**ADDENDUM
(AD)**

PROJECT: Nebraska Department of Transportation
District 1 Maintenance Facility
Seward, Nebraska

AD NO.: AD-2

DATE: December 10, 2024

11 SECTION DETAIL - WASHBAY / OFFICE
1 1/2" = 1'-0"

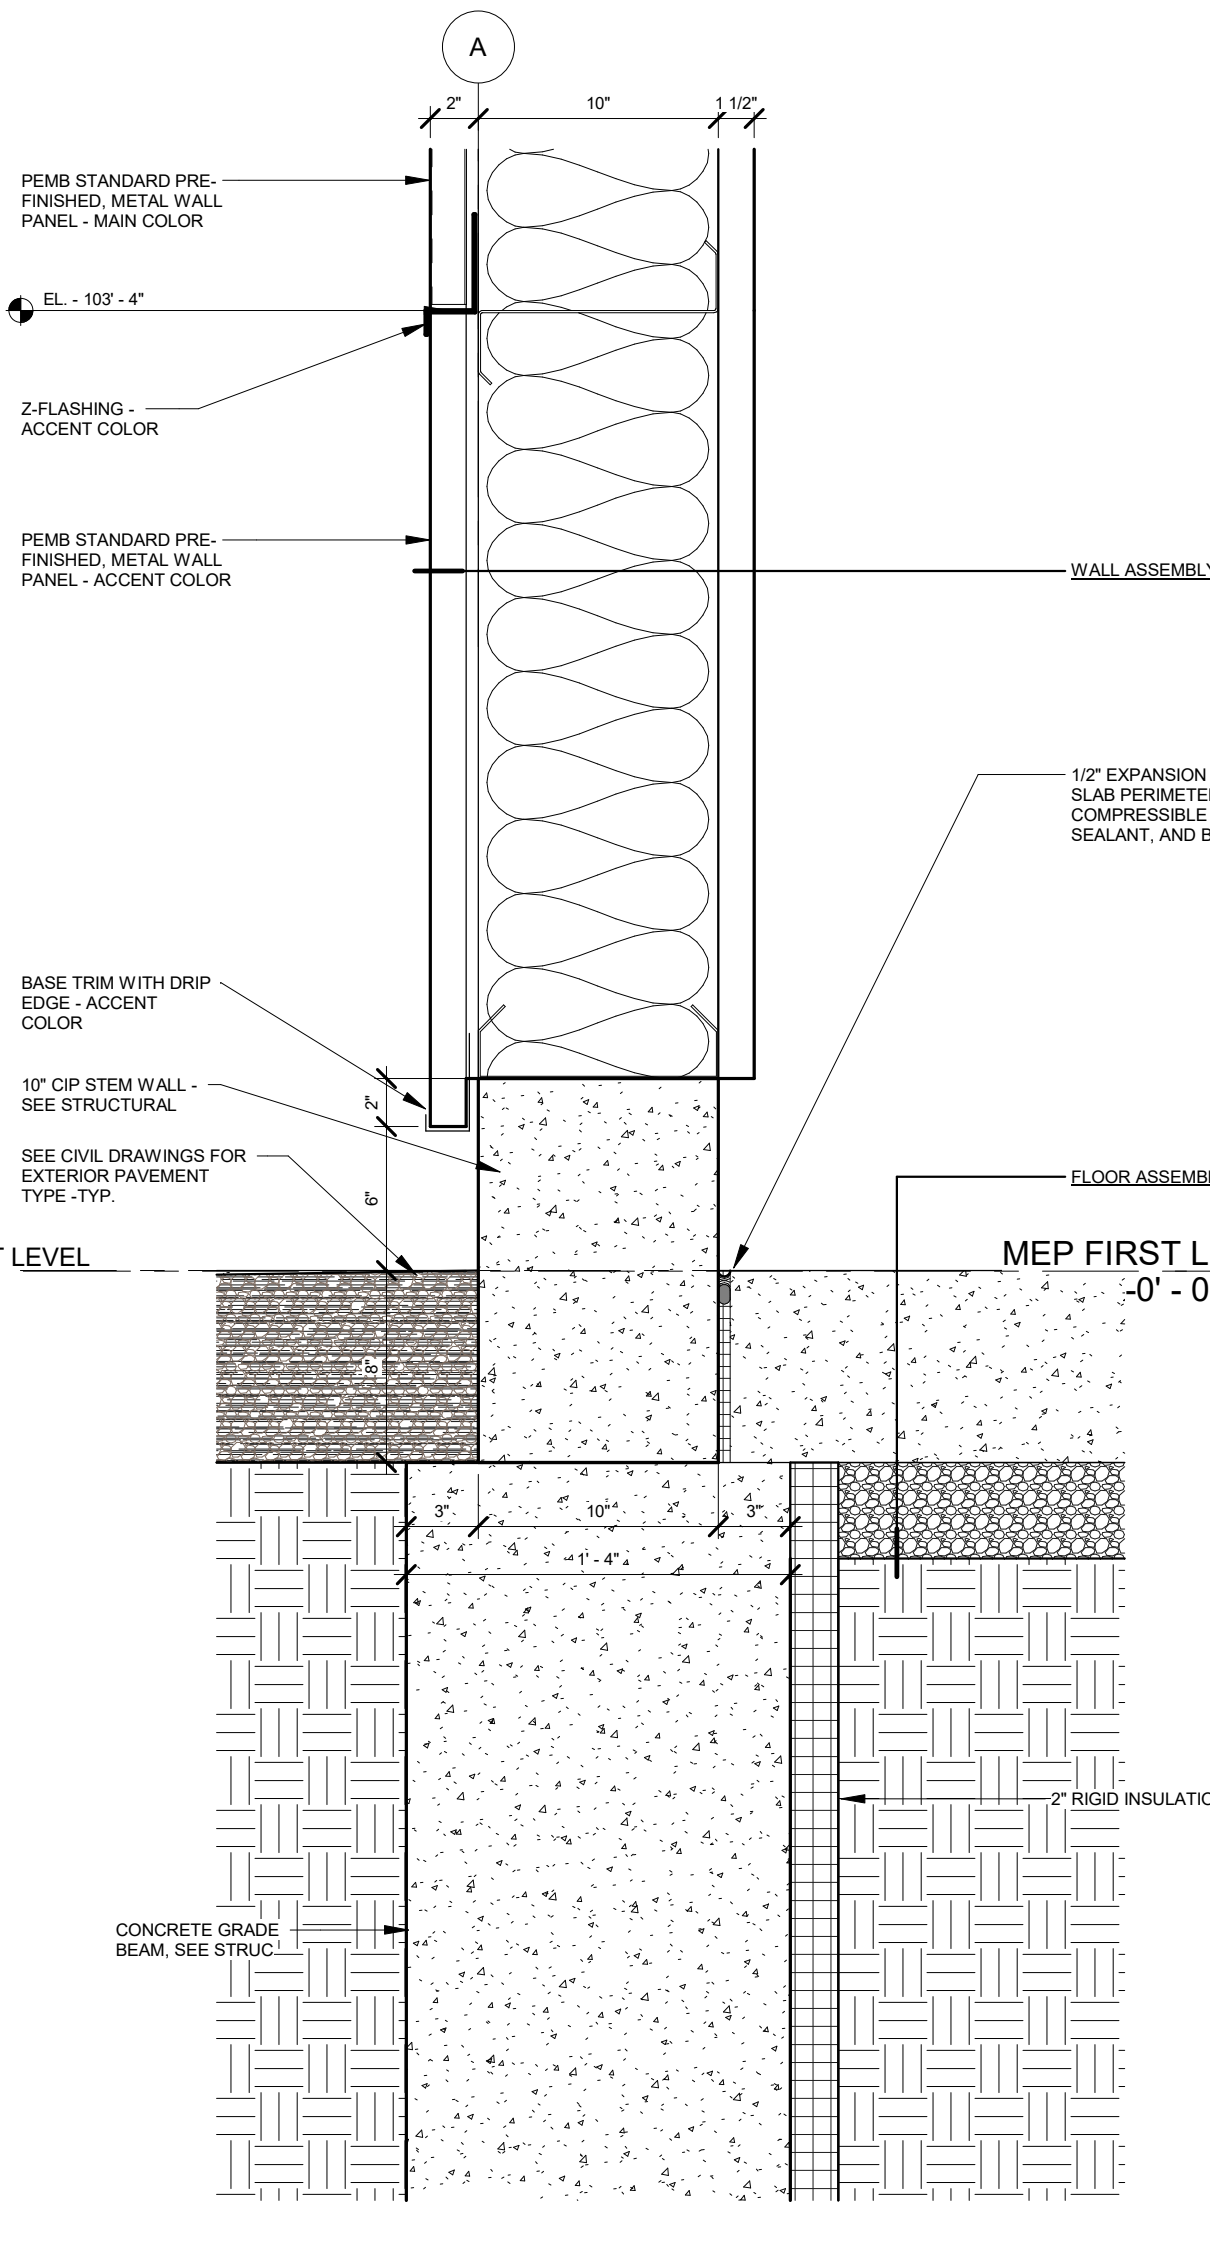
In reference to Sheet A-501 – WALL SECTIONS, see attached revised Sheet A-501. Section Detail 11 has been revised.

SHEET NUMBER
A-601

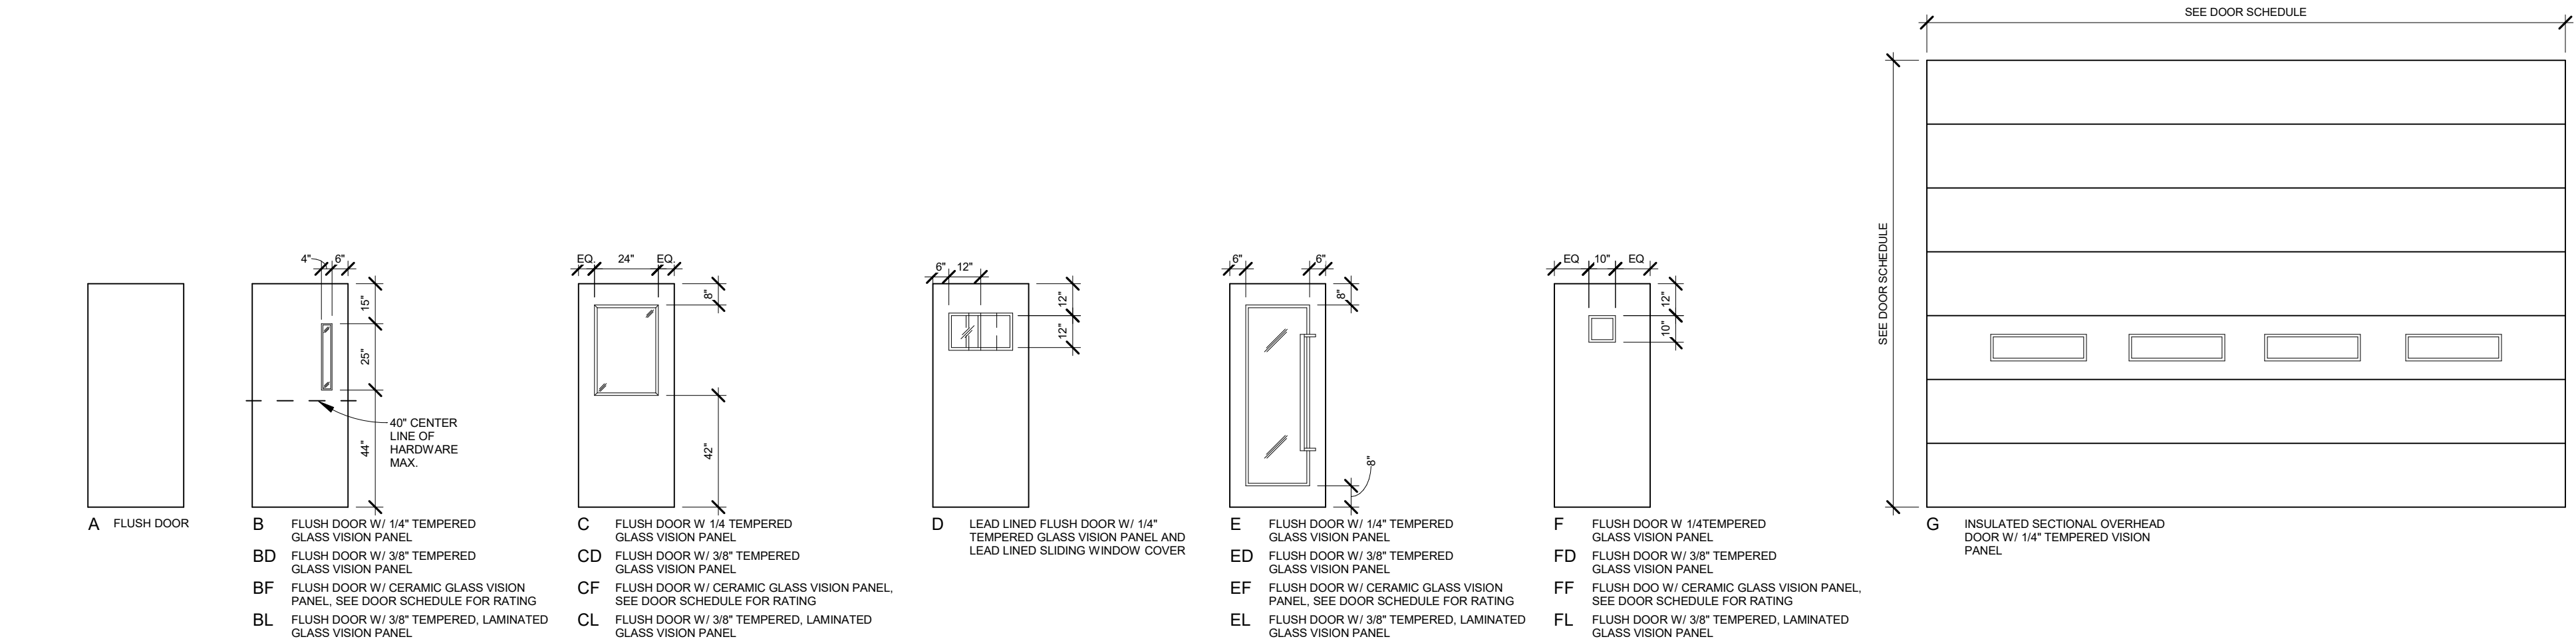
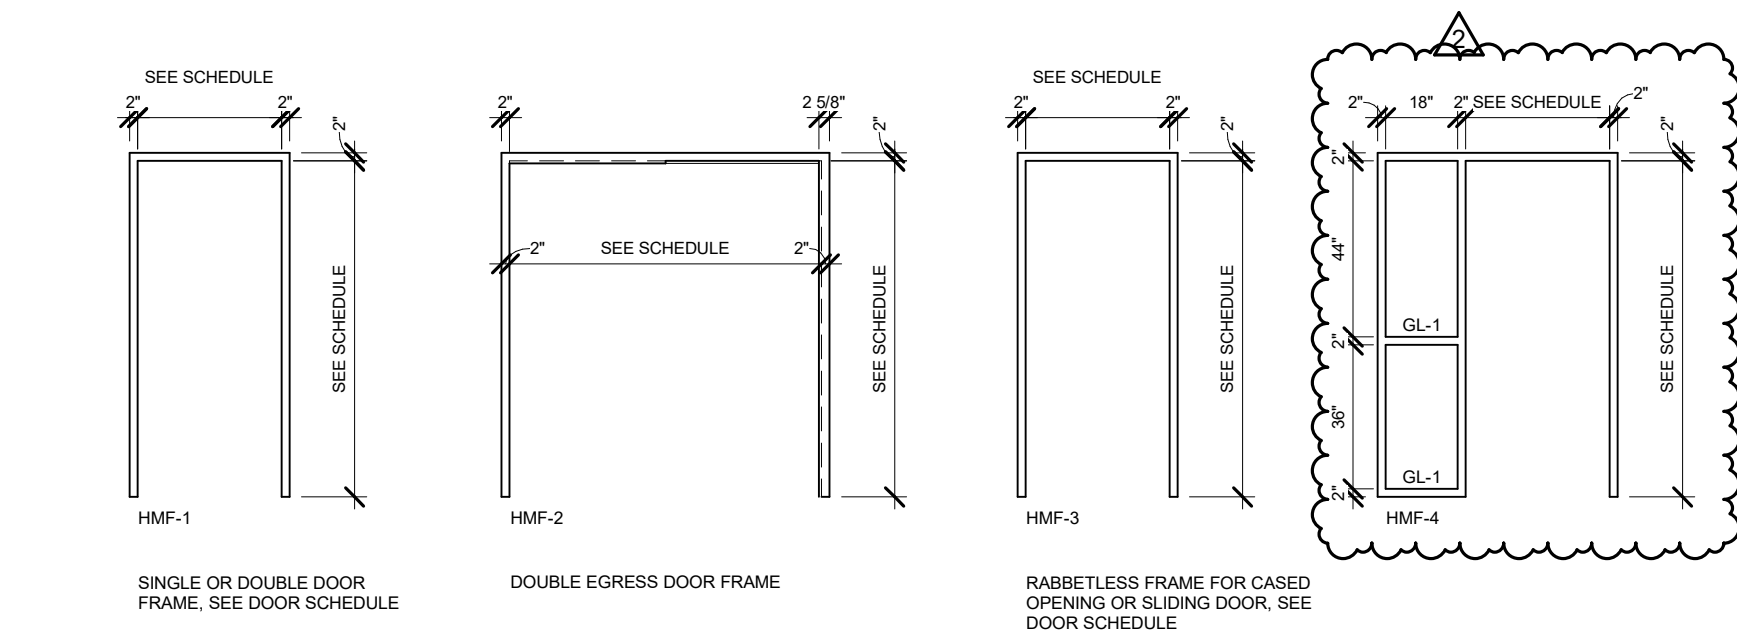
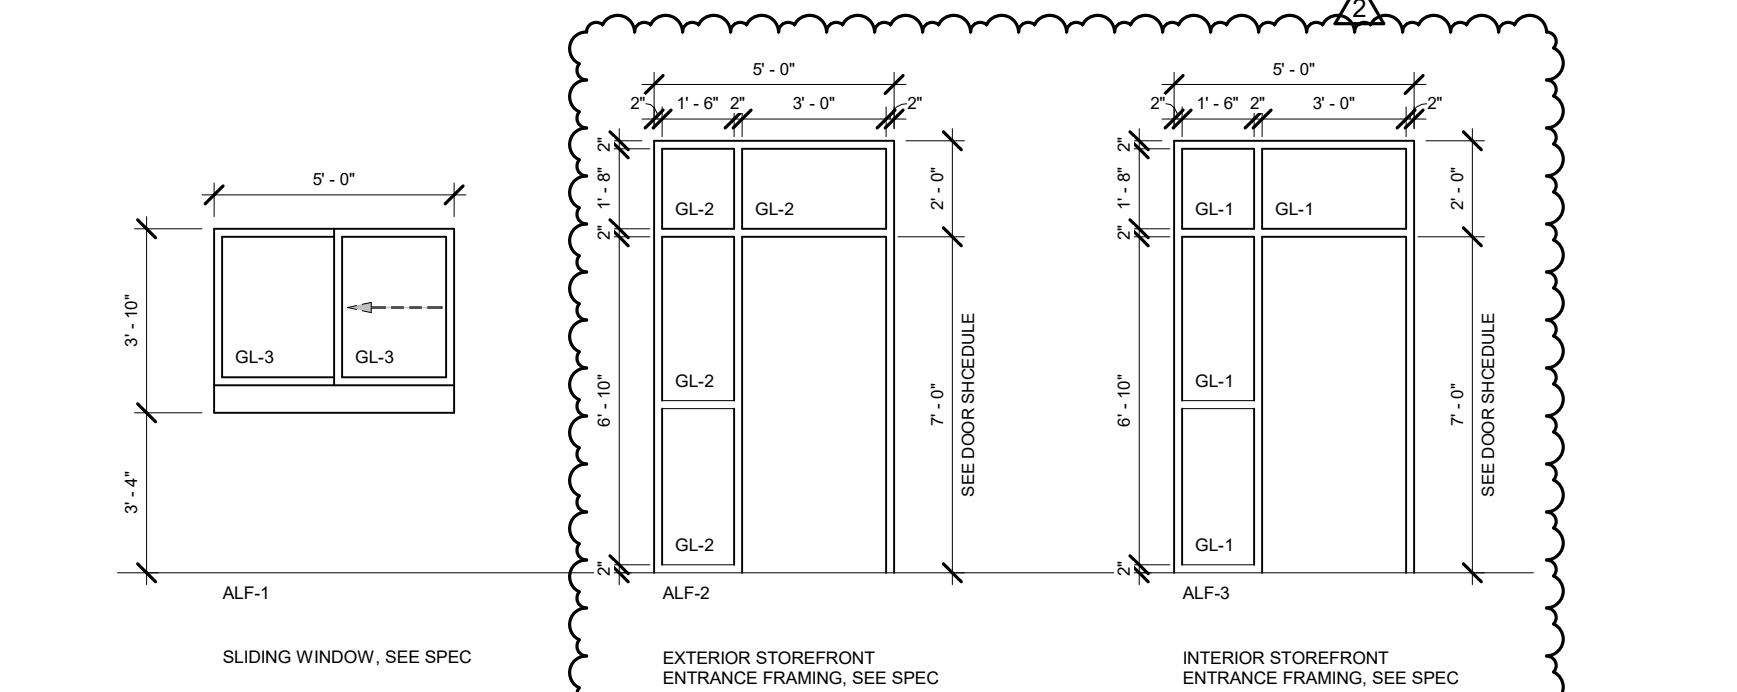
In reference to Sheet A-601 – DOOR SCHEDULE AND DETAILS, see attached revised Sheet A-601. Wall partitions have been added/ revised to the Partition Schedule. Aluminum door frame elevations have been revised. Hollow Metal Door Frame elevations have been revised. Door elevations for aluminum framed doors 116 A & 116 B have been revised.

Sheet Number
I-101

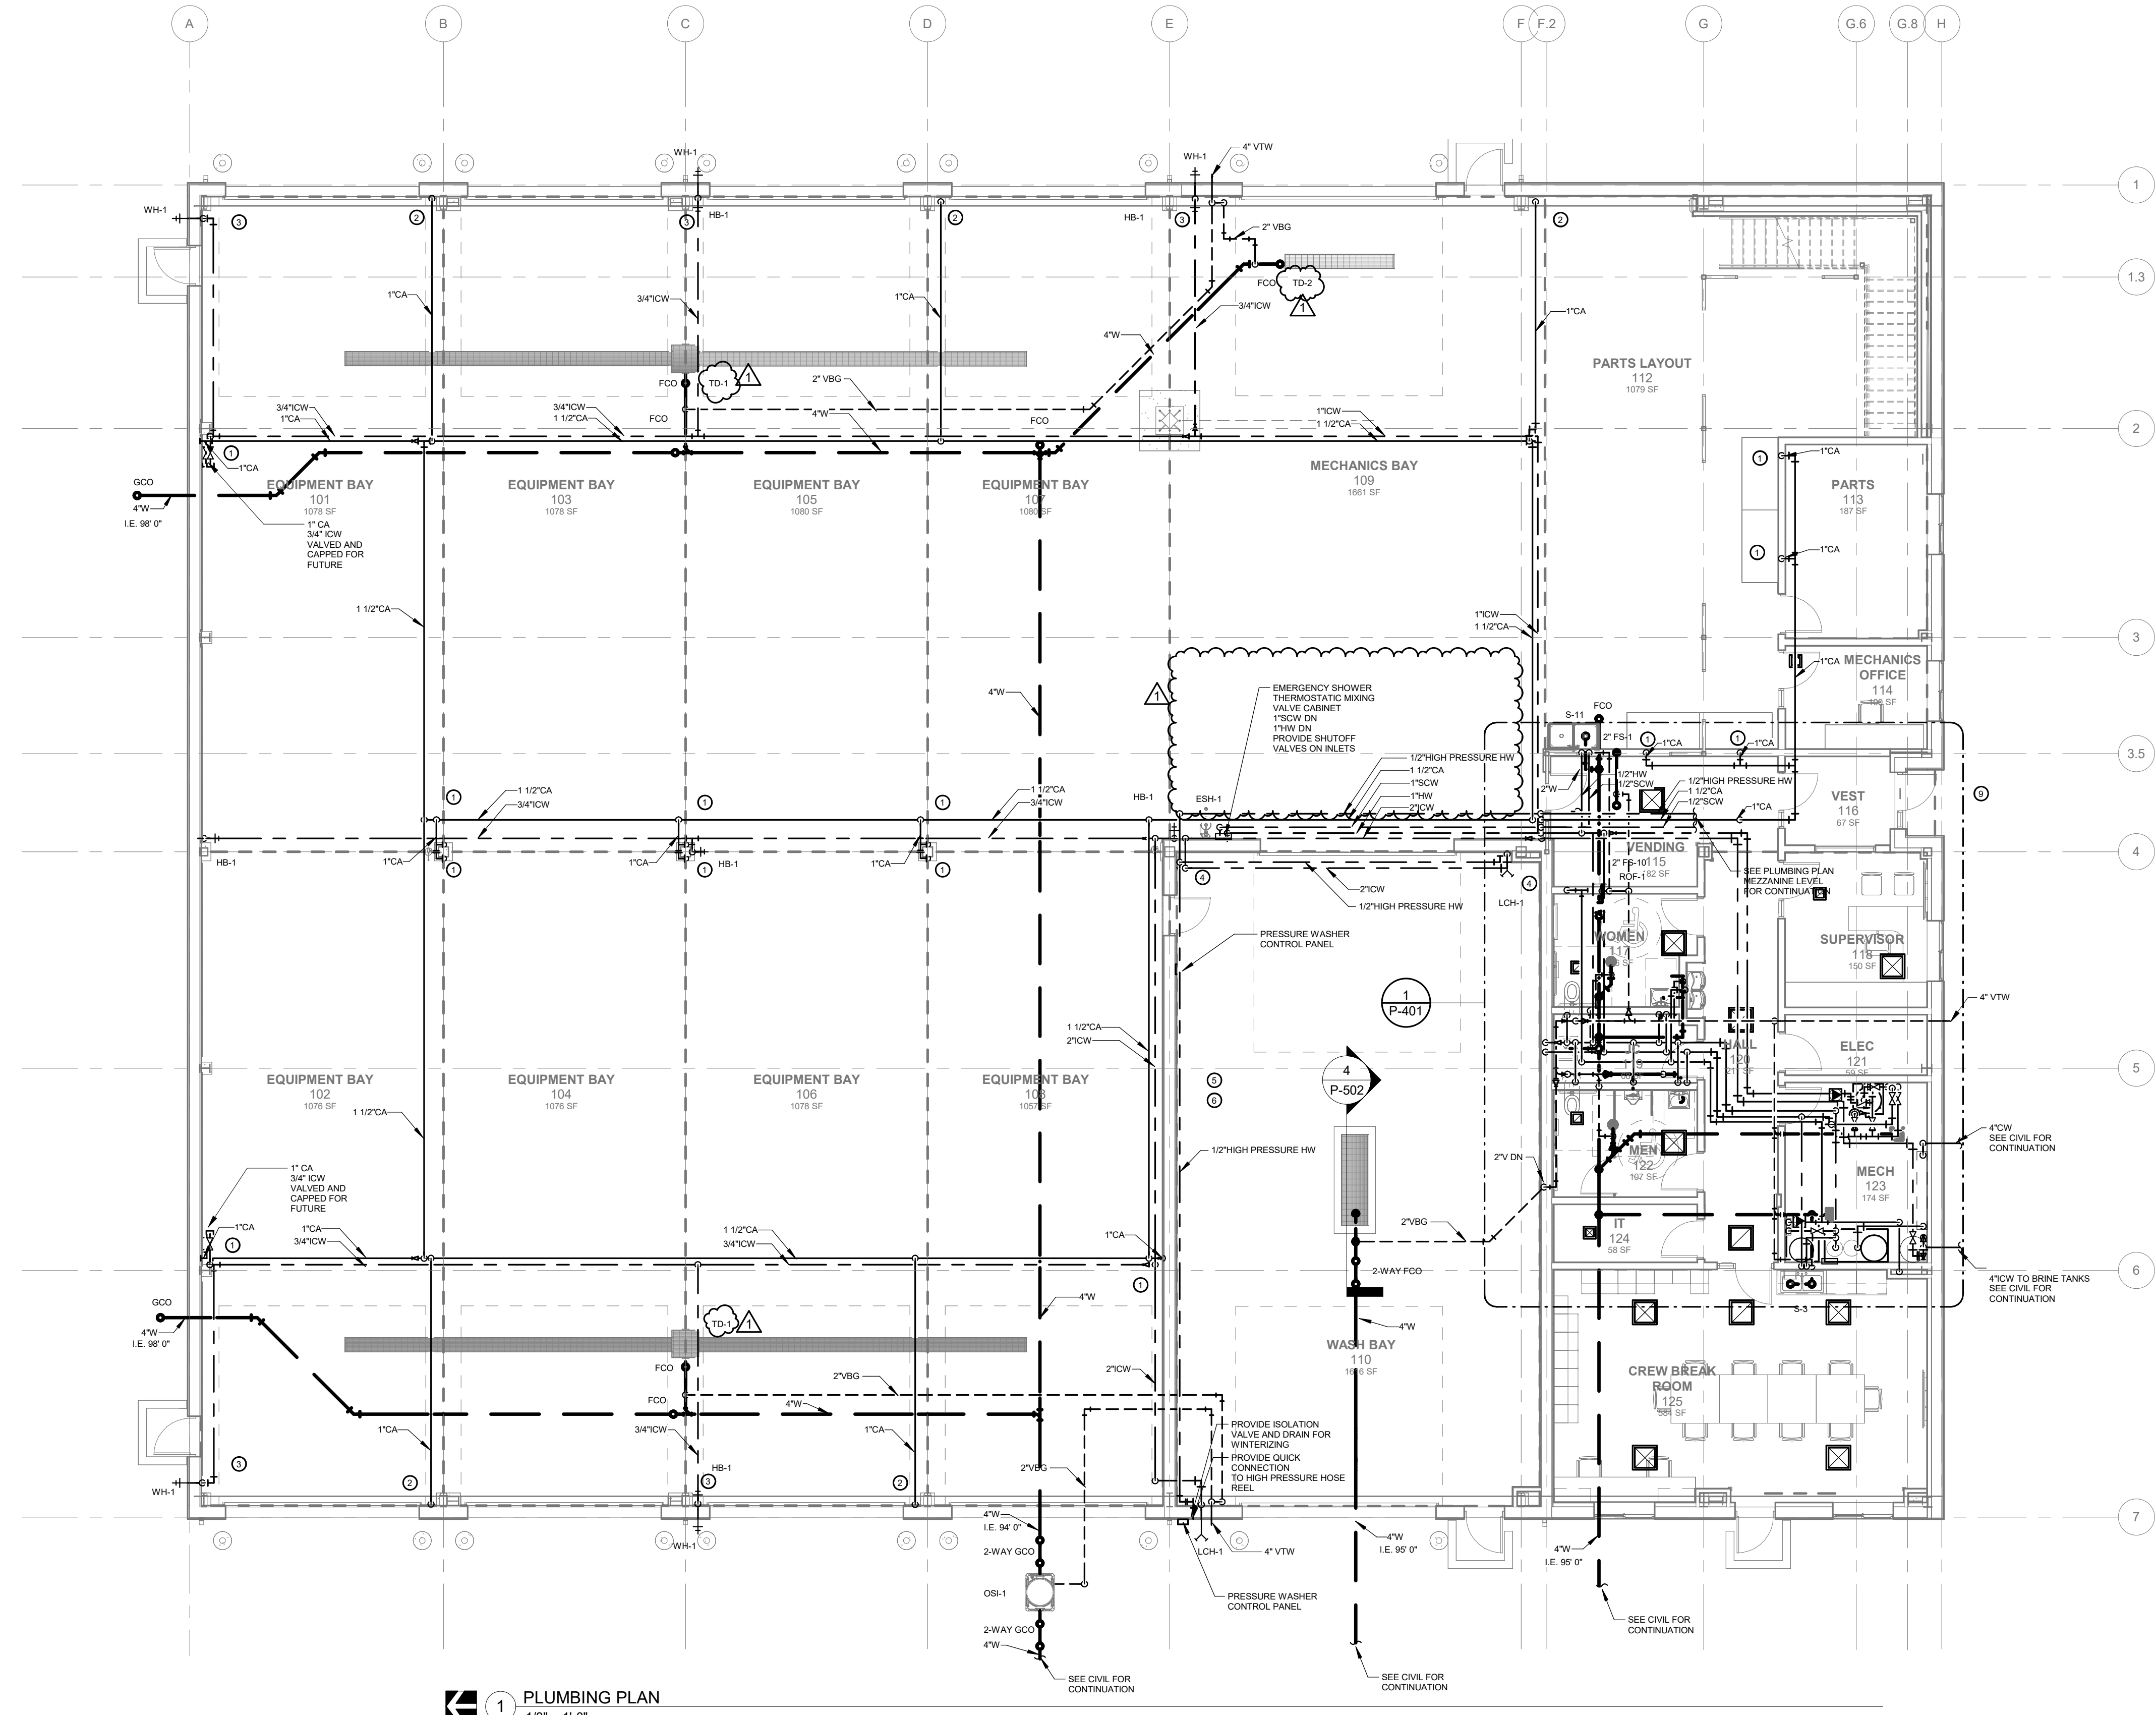
In reference to Sheet I-101 – FLOOR FINISH PLAN & SCHEDULES, Note 5. on the Room Finish Schedule (RFS) Notes, shall be removed from the Remarks Column on the Room Finish Schedule for Rooms 118 Supervisor or 125 Breakroom. Privacy Ceiling Blocker Tile and Privacy Soundproof Light Covers will not be used on this project.
